# Memo

**To:** The Atherton Planning Commission  
**From:** Sally D Bentz-Dalton, Town Arborist  
**CC:** ~~Stephanie B Davis~~ Radha Hayagreev, ~~Principal~~ Senior Planner  
**Date:** 4/22/2017/26/23  
**Re:** -Tree Protection Zone (TPZ) Exception 35 Isabella

Application for Ten (8) Heritage Tree Removals and Two (2) Tree Protection Zone Exceptions, 1 Edge Road

**Request #2:**

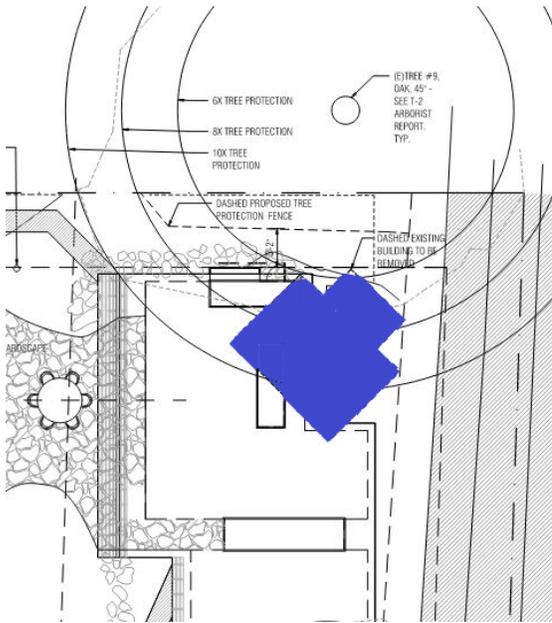
The applicant is proposing the new ADU location to be 22' away or 6x away. The applicant is proposing the structure to be no closer than the existing pool house.

The applicant stated that the neighbor has been contacted and a letter of support is forthcoming. No letter has been received at the time of this memo.

If approved, landscape screening will be required to screen ADU from neighbor and vice-versa.

If roots are encountered during foundation install and roots over 3" are encountered, then pier locations need to move to avoid the roots. The private arborist will be required to be on site for foundation work.

I can recommend the 6x if the structure does not cause any additional impacts to the neighbor's tree, then the current structure does, the neighbor provides support of the project and private arborist is on site and no roots over 3" are cut.

- Private arborist on site during foundation work.
- Hand excavation only within 8x TPZ.
- Mulch should cover all bare soil within the tree protection fencing. This material must be 6-8 inches in depth after spreading, which must be done by hand. Coarse wood chips are preferred because they are organic and degrade naturally over time.
- Sufficient tree protection of the two trees during demo and install.
